In re Application of: Dan ROTTENBERG et al
Serial No.: 10/597,666
Filed: June 20, 2007
Office Action Mailing Date: March 28, 2008

REMARKS

(54) Title: DEVICE AND METHOD FOR CONTROLLING IN-VIVO PRESSURE

LETTER TO CHIEF DRAFTSMAN

FIG. 1A

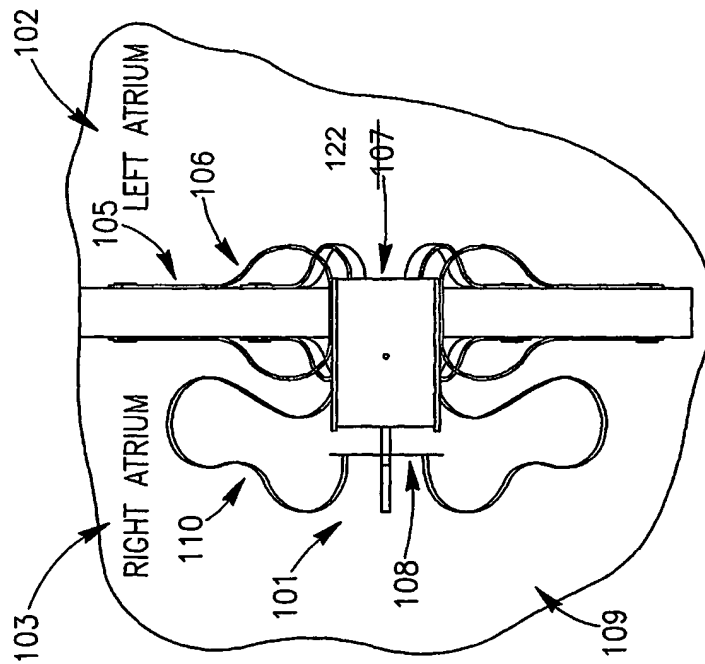
The Examiner objected that some terms used in paragraph [0036] of the specification, and as reflected in FIGS. 1B – 1I, were “unclear, inexact or verbose” within the meaning of 35 U.S.C. 112. In particular, the Examiner suggested “that the numbering of the same features should be given the same number, such as “shunt 122” should be changed to - - shunt 107 - - or - - shunt 107B ...”. The Applicant has carefully considered the Examiner’s suggestion and made the following amendments:

Permission is requested to correct Figure 1A as shown in red ink on the attached photocopy.

- in the drawings, FIG. 1A has been amended by changing number “107” to “122”; and
- in the specification, references to “shunt 107” in paragraphs [0036], [0037], and [0044] have been changed to “shunt 122”.

As a result of the above amendments the shunt shown in FIGS. 1A-1I and described in corresponding portions of the description is now uniformly referred to as “shunt 122”.
